BY EMAIL AND
BY CERTIFIED MAILAssociate Administrator for Enforcement
National Highway Traffic Safety Administration
Attention: Recall Management Division (NVS – 215)
1200 New Jersey Avenue, SE.
Washington, DC 20590Re: **PART 573 NOTICE RE IDLER PULLEY COVER**

Safety Defect and Noncompliance Report Guide for Vehicles
PART 573 Defect and Noncompliance Report

MCI Service Bulletin 351

The MCI D series motor coaches equipped with an idler pulley cover, part number 06-06-1629 revision A.

NOTES:
 1) POSITION STITCH WELDS SO THAT STITCH CONTINUES AROUND CORNERS
 2) PRIME BOTH SIDES, PAINT IRON #8248 YELLOW
 COVER ASSY - IDLER PULLEY
 06-06-1629 REV B

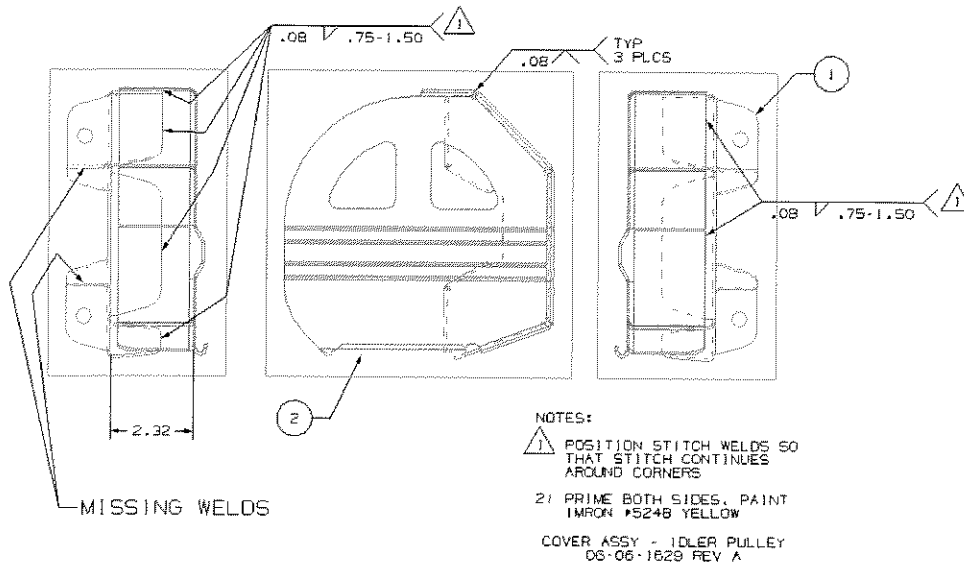
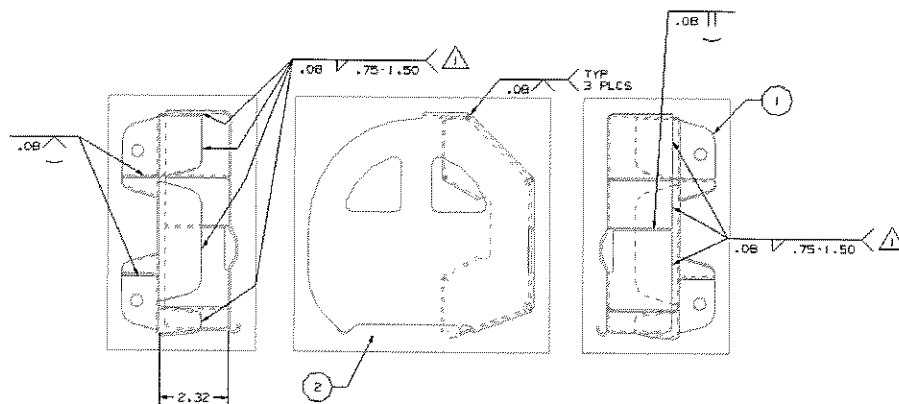
The recalled vehicles have a yellow pulley guard, MCI part number 06-06-1629 revision A. The part is defective if there are no welds present at the positions shown in the attached drawing. The pulley guard covers the idler pulley, which acts as a guide for the belt that drives the engine cooling fan. It is located in the engine compartment at the rear of the coach and is visible only when the engine compartment doors are open.

The fan belt idler pulley is designed with a guard to prevent personal injury to maintenance personnel who might otherwise come in contact with the fan drive belt at the idler pulley during maintenance operations. MCI determined that the design of the pulley guard is susceptible to fatigue failure in the area where the guard is fastened to the coach if two welds joining the attachment flange to the cover are not present (see drawing in section I above).

MCI has determined that the defective pulley guards lack two welds that provide stiffness and rigidity to the part. Without these welds, the guards will likely eventually fail as a result of fatigue near the area where the guard is assembled to the coach structure. The following pictures show where the part fails.

MCI will provide, at no cost to customers, the parts and labor to replace the defective part 06-06-1629 revision A on all affected coaches with new part 06-06-1629 revision B. The procedure to replace defective parts is defined in MCI Service Bulletin 351.

Clearly describe the distinguishing characteristics of the remedy component/assembly versus the recalled component/assembly.

The recall condition was corrected in production at unit number 59648 by reworking defective parts. The rework consisted of removing the defective part from the coach, welding the two attachment tabs, and refitting the part on the coach. All units from 59648 to 59689 were reworked in this way in MCI's production facility. MCI introduced the new part (06-06-1629 revision B) into production at unit 59690. The new part (06-06-1629 revision B) supersedes the defective part (06-06-1629 revision A). The remedy for affected coaches in the field is the same as MCI implemented in production.
